PCN #: 2485 – Rev 3 (Automotive)

PCN Title: Qualification of Internal "Diodes Technology (Cheng Du) Company Limited" (CAT) as Additional Assembly & Test Site Using PdCu or Au Bond Wire, And Qualification of Additional Wafer Source for Select Discrete Automotive Products

**PRODUCT CHANGE NOTICE**

**PCN-2485 REV 3**

**PowerDI5060-8L**

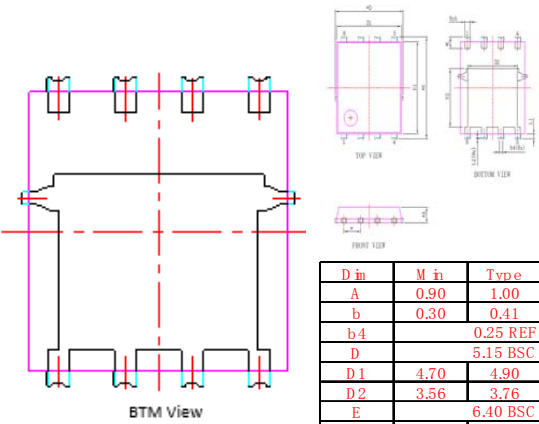
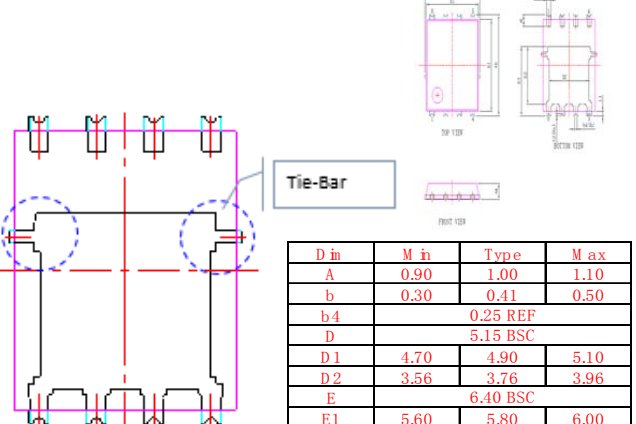
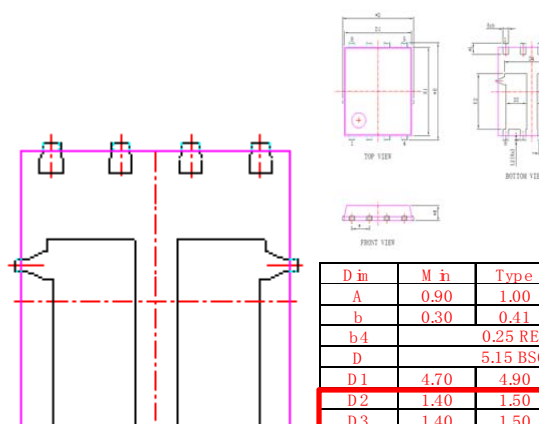
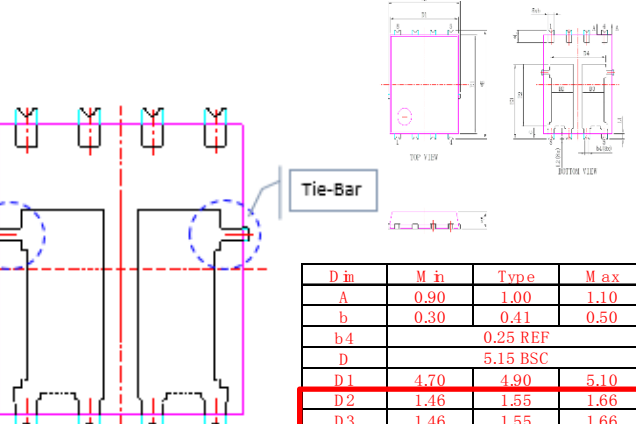
<b>SAT (Current Diodes Internal AT site Shanghai, China)</b>	<b>CAT (Diodes Internal AT Site Chengdu, China)</b> <b>Bar "-" above Y indicates CAT</b>
Marking format example	Marking format example
 <p>DII = Manufacturer's Marking          ABCDEFG = Product Type Marking Code          YYWW = Date Code Marking          YY = Year (ex: 13 = 2013)          WW = Week (01 - 53)</p>	 <p>DII = Manufacturer's Marking          ABCDEFG = Product Type Marking Code          YYWW = Date Code Marking          YY = Year (ex: 13 = 2013)          WW = Week (01 - 53)</p> <p>Other marking layout also will follow change for site Identifier</p>
